**Amendments to the Drawings:**

**Remarks/Arguments**

# REPLACEMENT SHEET (Annotated)

Fig. 7

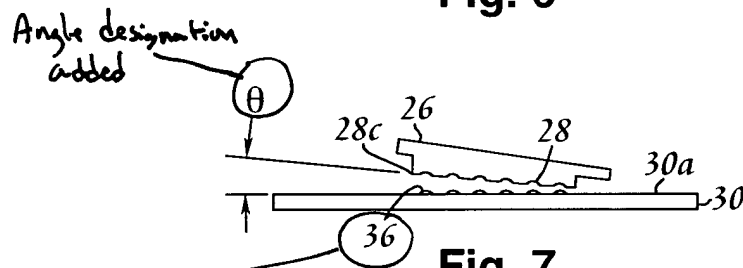
The Examiner has objected to the drawings because: "Fig. 7 has unidentified lumps on the surface (30a) and are somewhat unclear due to the poor or rough quality of the drawings." Office Action, at 3.

The attached sheer of drawings includes changes to Fig. 7. This sheet, which includes Figs. 6-8, replaces the original sheet including Figs. 6-8. In Fig. 7, previously unnumbered element 36 has been so numbered.

Applicant has herein amended Fig. 7 to properly number droplets 36 on the surface 30a. See attached replacement drawing sheet.

Angle designation added

numbering of droplets 36 added
